## Operator's Manual

MODEL NO. 30196 – 890001 & UP  
MODEL NO. 30197 – 890001 & UP

## ADDENDUM

### Adjust PTO Bellcrank

**Figure 1**

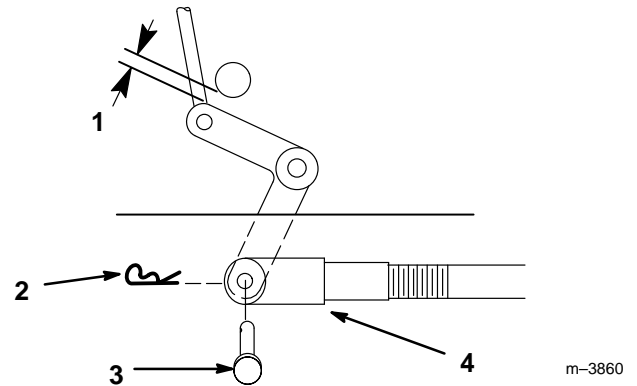
The following adjustment has been added to the unit. Keep this sheet with the Operator's Manual for reference.

1. Engage PTO lever and check the clearance between the bellcrank and the axle shaft (Fig. 1). Space should be  $1/4''$  (6mm).
2. If adjustment is required, remove hairpin cotter and clevis pin from bellcrank. Rotate clevis clockwise on rod to increase or counterclockwise to decrease clearance (Fig. 1).
